| Project Title: | Carlsbad Energy Center - Compliance |
| Document Title: | Project Owner's Responses to Data Requests in Set One (Nos. 1-30) |

Re: Carlsbad Energy Center Project Petition to Amend (07-AFC-06C)
Project Owner's Responses to Data Requests in Set One (Nos. 1 - 30)

Data Response Set 1 (Responses to Data Requests 1 to 30)

FIGURE TSE1c-5
138 & 230kV Line Pole Cross-section
Double Circuit Deadend Configuration
Line Divergence Point

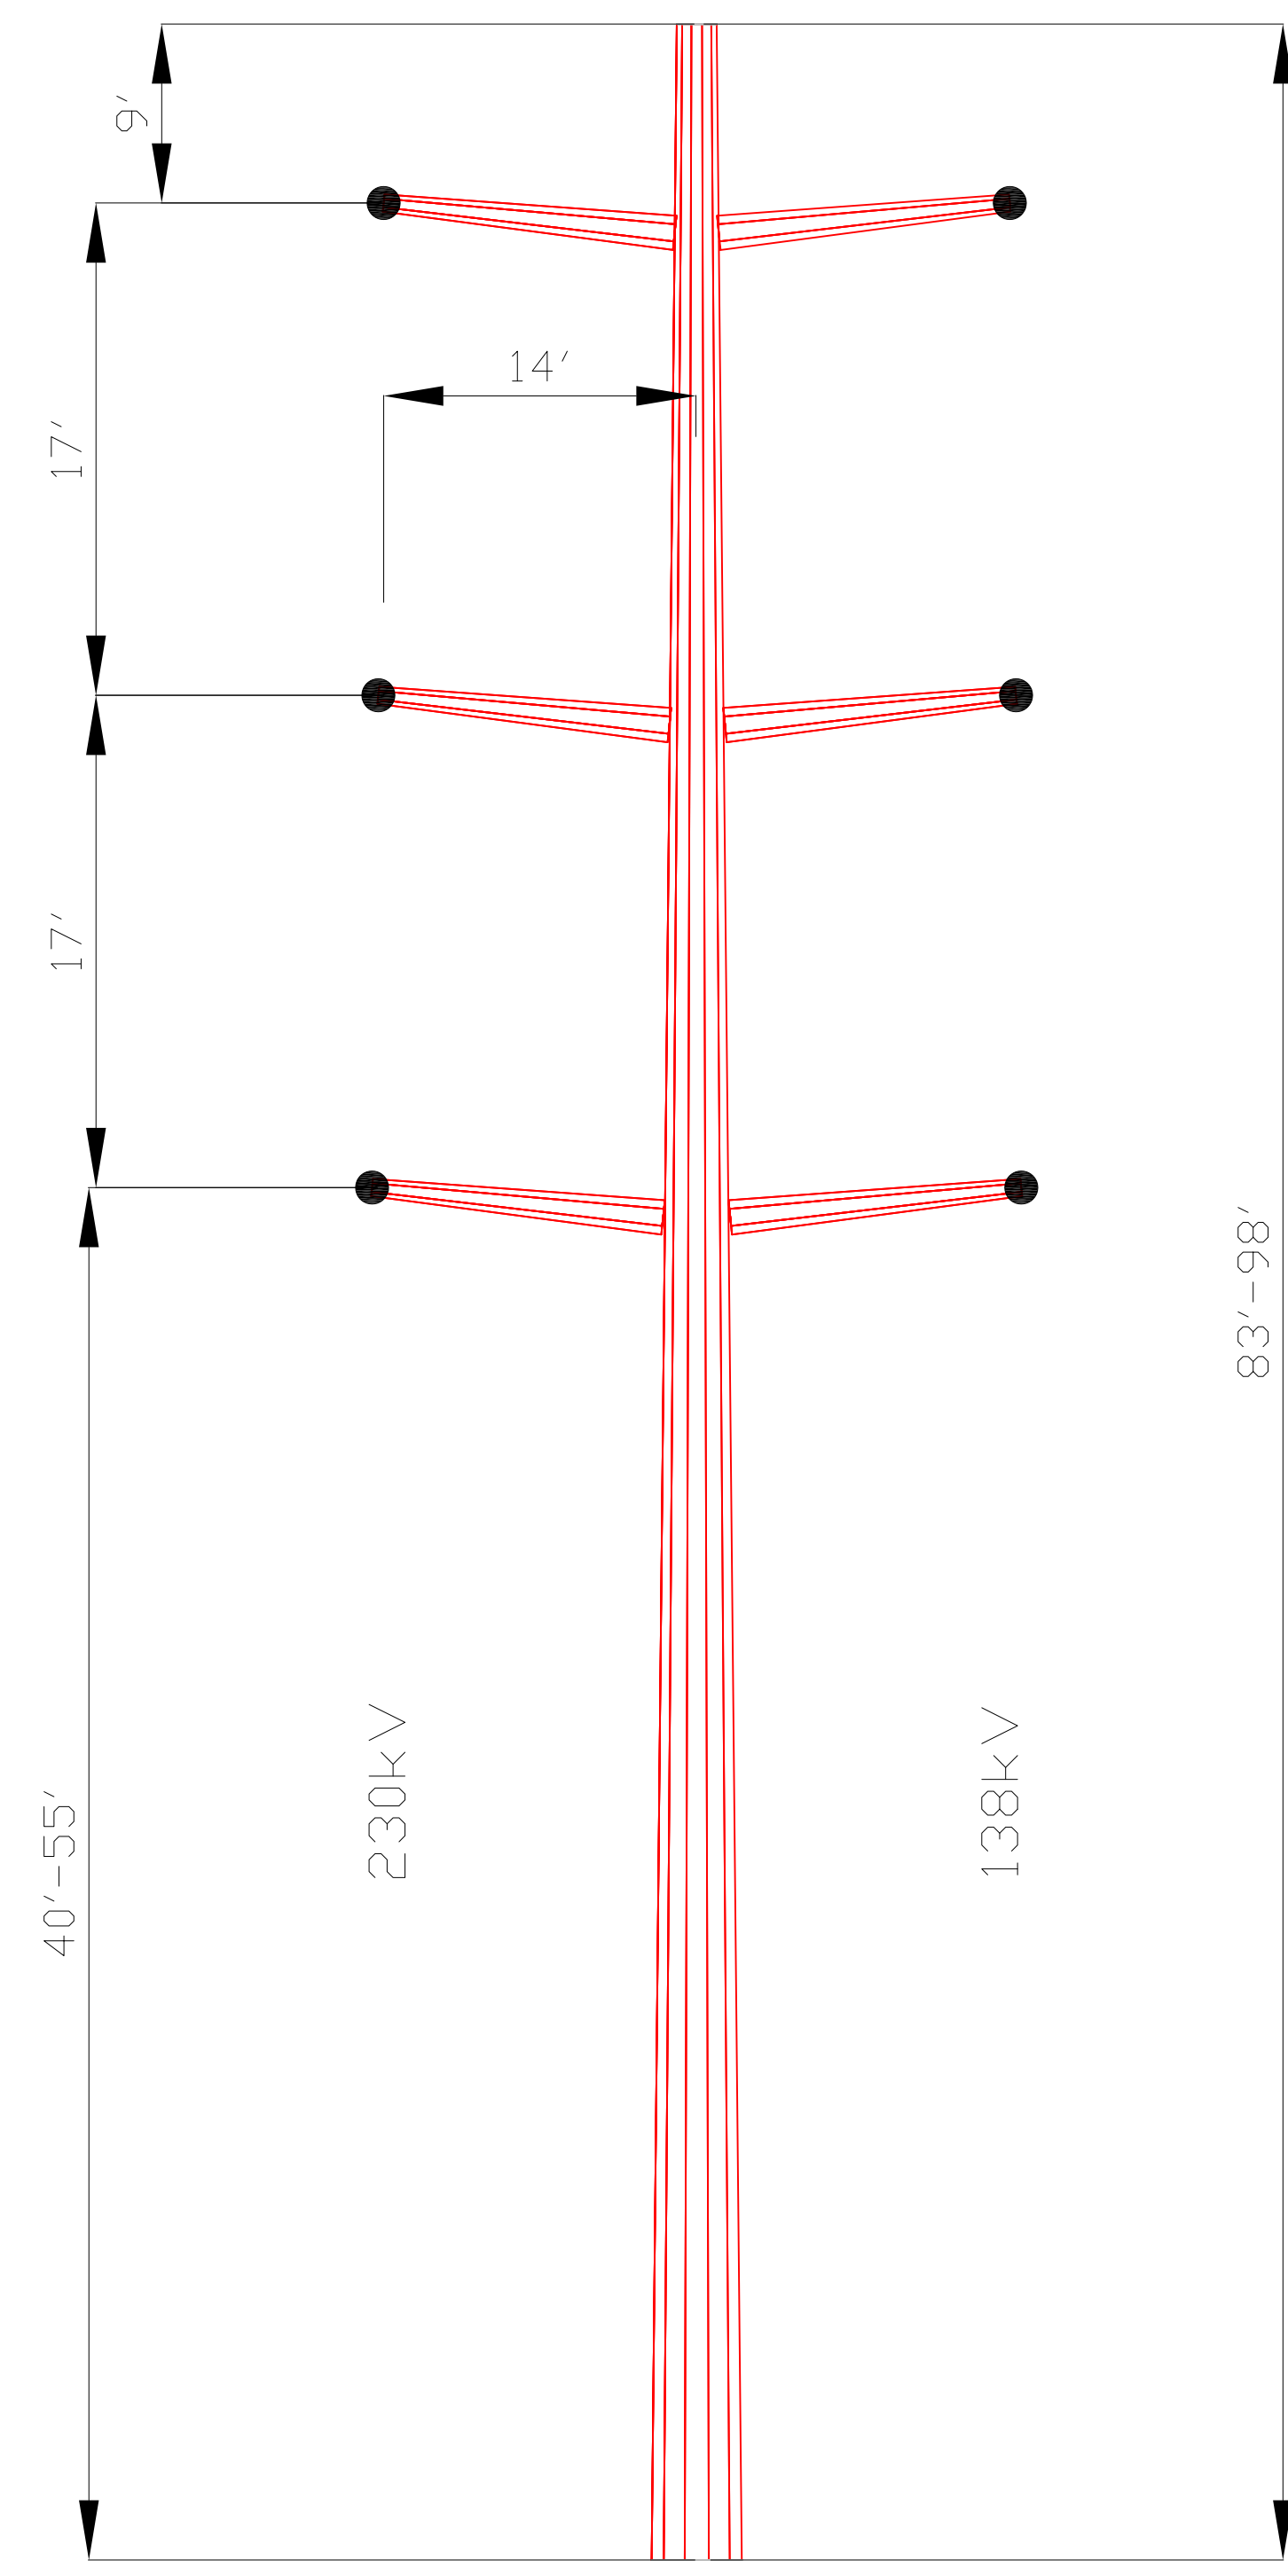
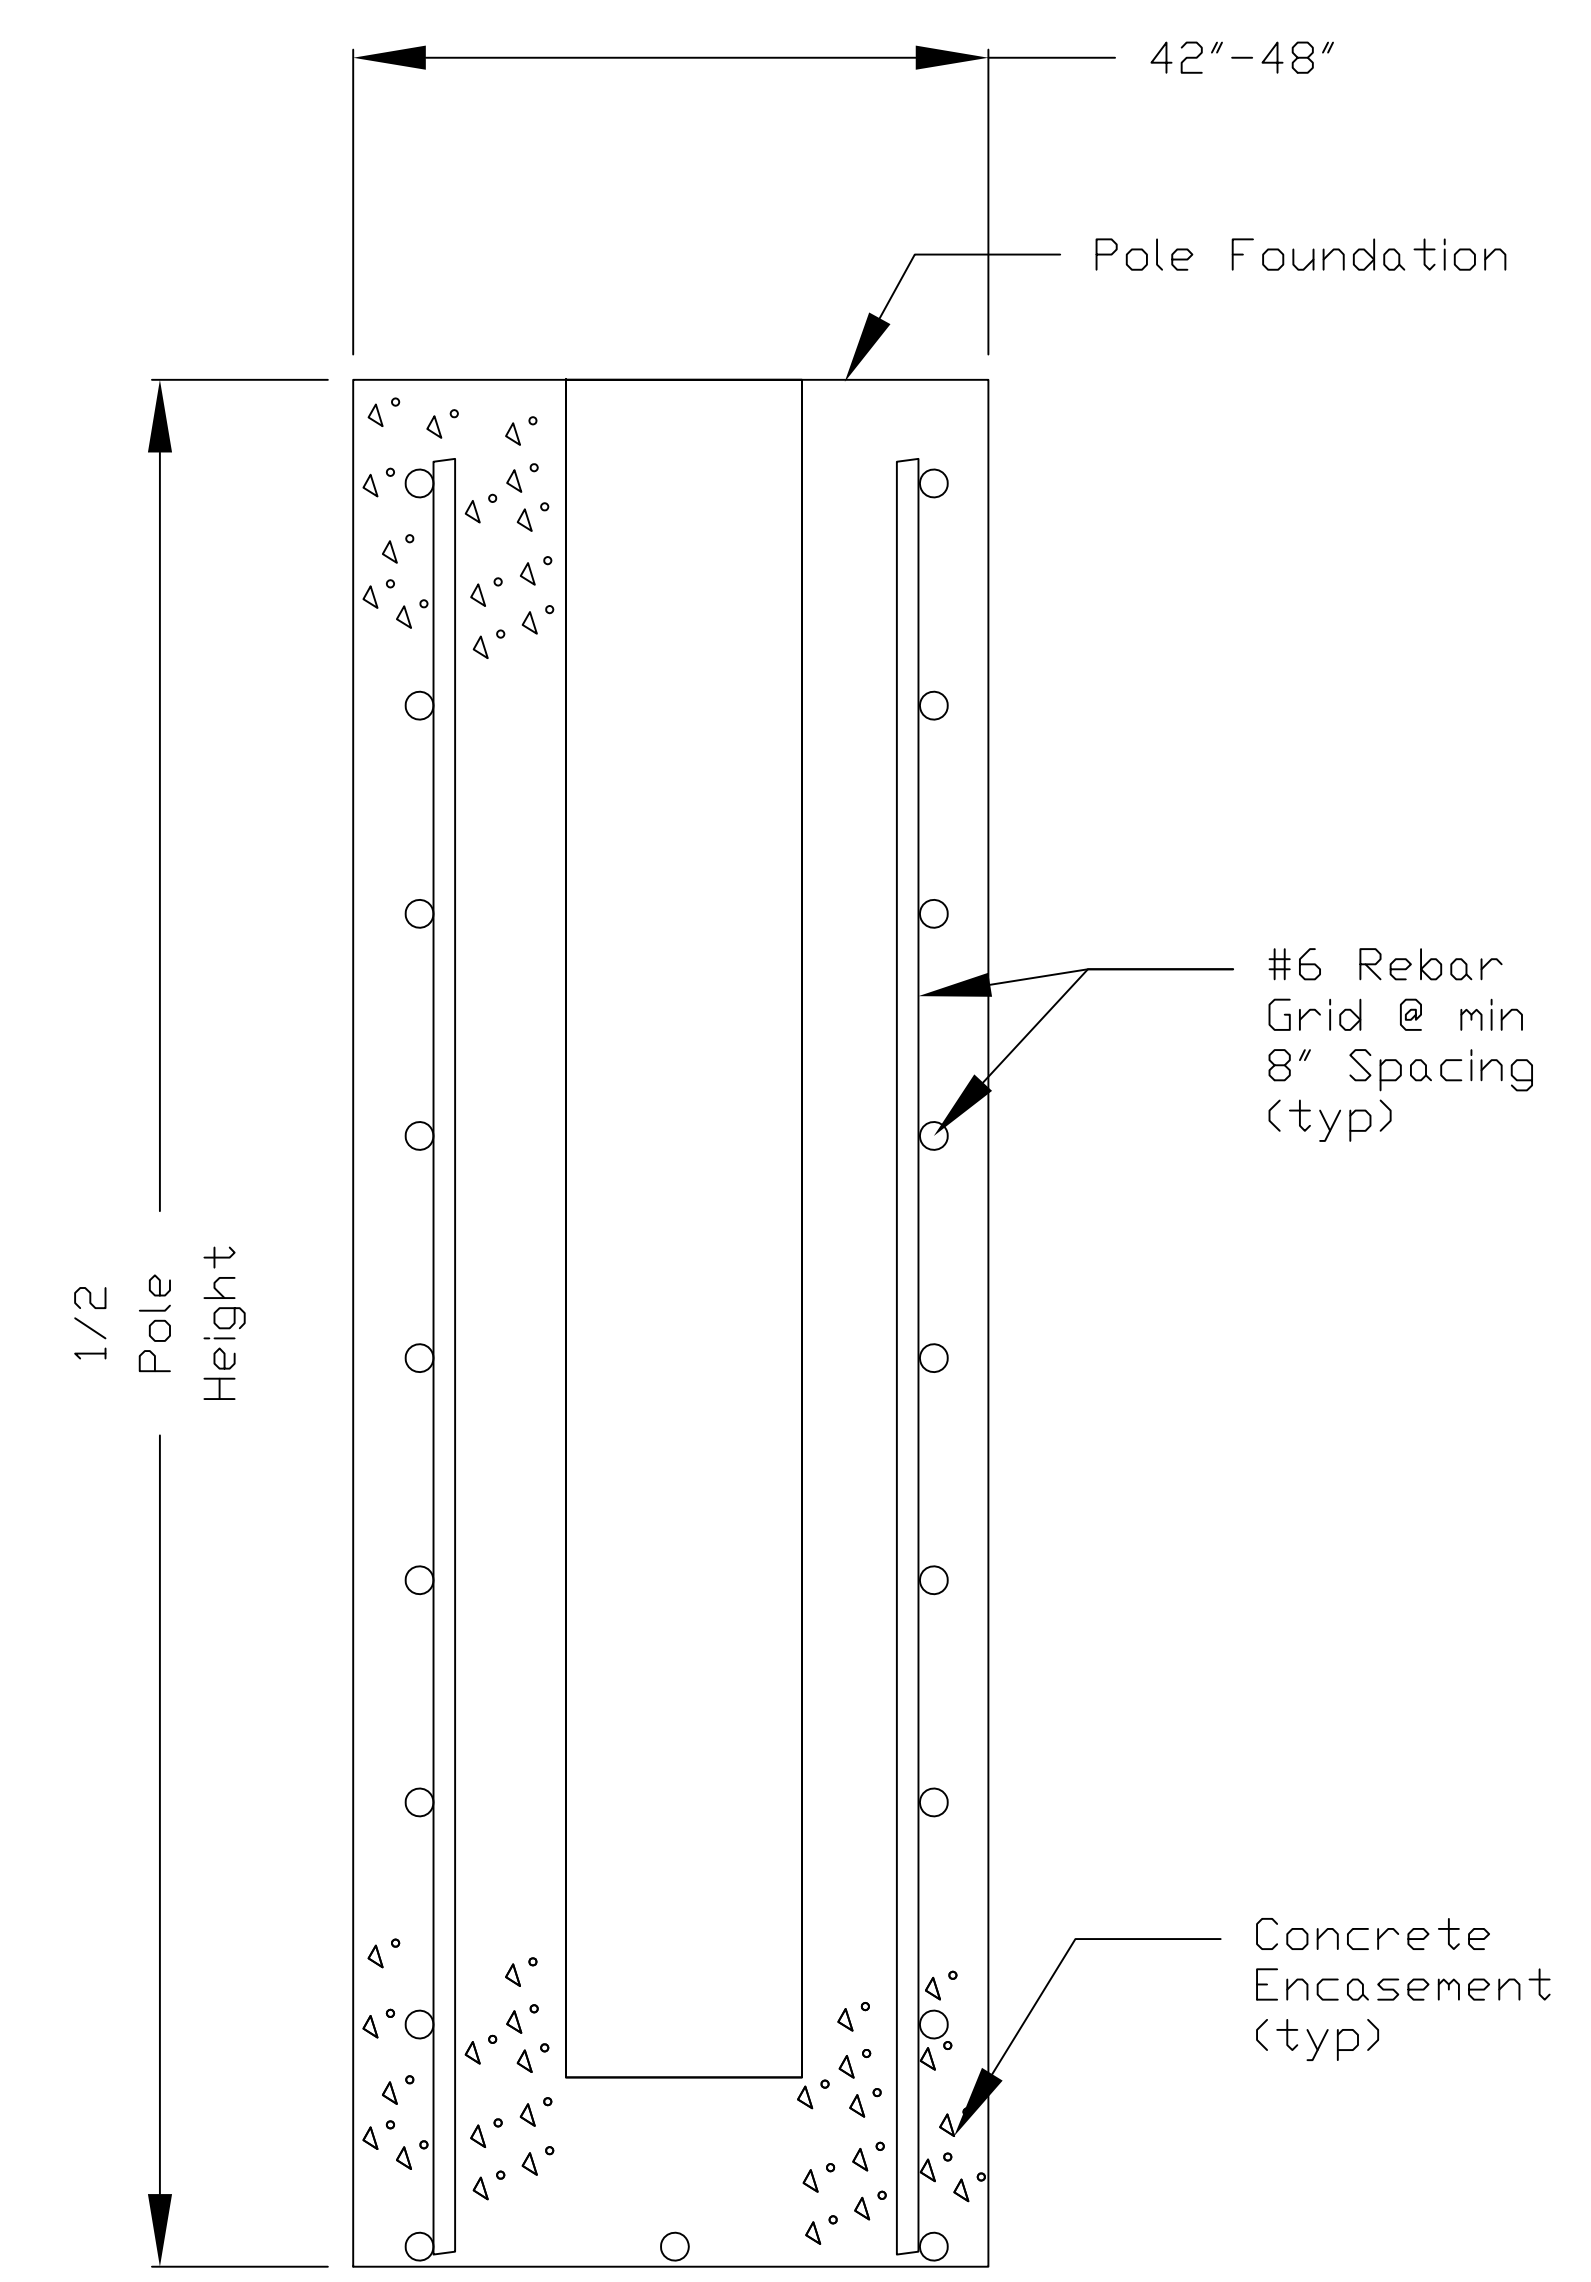
24. Resubmit 138 kV single line dead-end pole diagram (Figure 3.1-5) and 230/138 kV double circuit tangent and dead-end pole diagrams (Figures 3.1-6 & 3.1-7) design diagrams stating type of the pole(s) (steel or wood or any other), length of the insulators, and size & type of overhead conductors. Please show the height of the poles below and above the ground level, conductor-position measurements for the 230 kV and/or 138 kV side of the pole, and between conductors of both sides. Also show and describe any ground conductors, including their size, and provide the ground clearance distance from the lowest conductor on the pole.

Project Owner hereby submits revised versions of the pole drawings that were submitted in the PTA , containing additional information. These are Figures DR24-1 (corresponding to PTA Figure 3.1-5), DR24-2 (PTA Figure 3.1-6), and DR24-3 (PTA Figure 3.1-7). Overhead conductor sizes are shown on Figure DR22-2.

Response: As noted in Project Owner's objection to this Data Request, 138 kV single line tangent poles are not required in the current design of the transmission line and diagrams of them will not be submitted. 138kV/230kV double-circuit poles will be used instead, and Project Owner has included a diagram of this pole type as Figures DR24-2 and DR24-3 below.

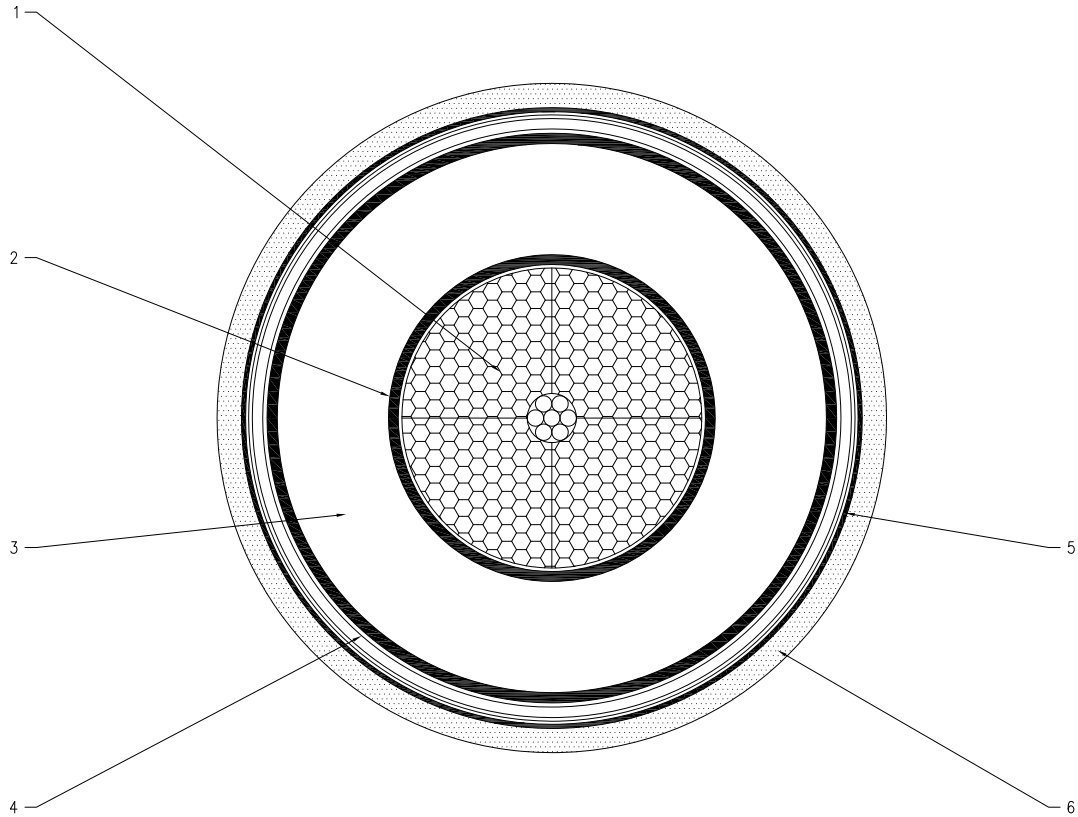
26. Provide the length, type, size, and ampere-rating of the proposed single-core UG 230 kV cable line. Submit a design drawing diagram of the proposed UG 230 kV single-core cable line termination on the 230 kV overhead dead-end pole structure showing position of the rising cable line on the pole, distances between cable terminating insulators and jumper cables to the overhead line. Also describe with a diagram how the cable line would be terminated at the SDG&E 230 kV switchyard.

Response: A drawing with the data for a typical 230kV cable line has been included as Figure DR26-1. A diagram showing the transition structure from overhead to underground has been included, Figure DR26-2. A diagram showing the cable termination in the SDG&E 230kV switchyard is included as Figure DR26-3.

Trench_Detail_2X2.dwg

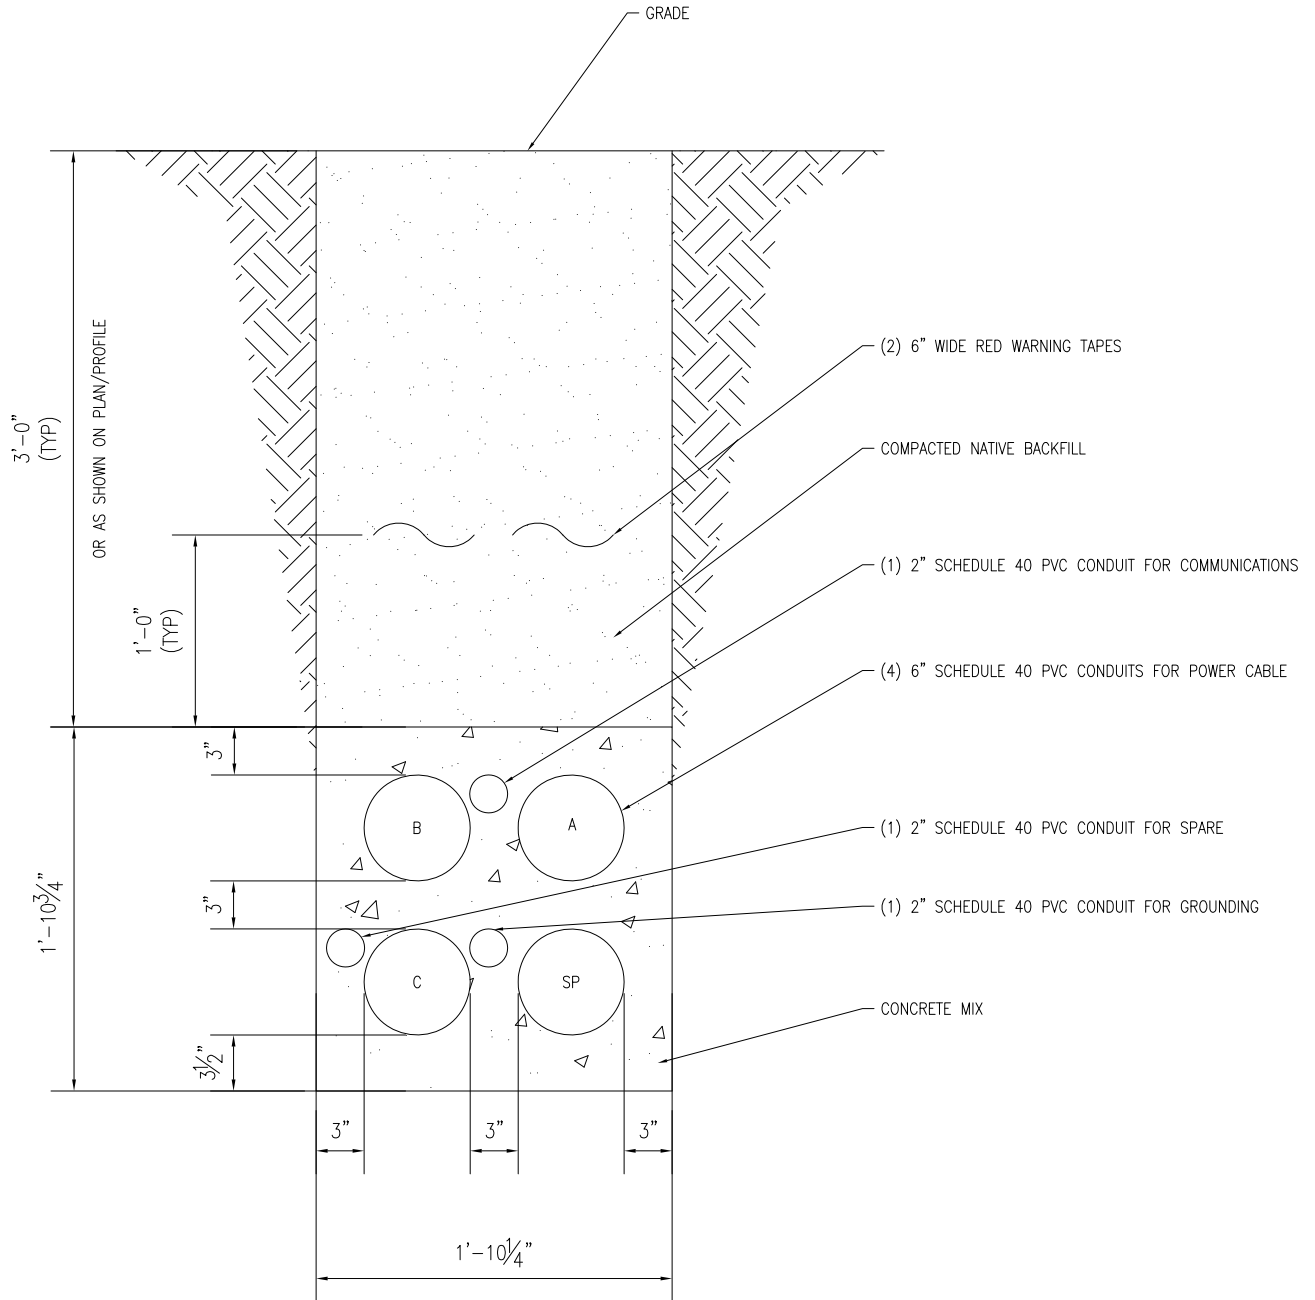
27. For the 230 kV UG single-core cable line, submit a drawing for typical Duck Bank type construction embedded in concrete showing its width and height, and four PVC cable conduits with sizes suitable for drawing the selected three single-core UG cable lines with a spare one and an additional smaller conduit grounding and

communication cables. Provide the vertical and horizontal distances between the conduits and the ground surface including depth and type of backfill.

Response: A typical duct bank drawing is included, Figure DR27-1.
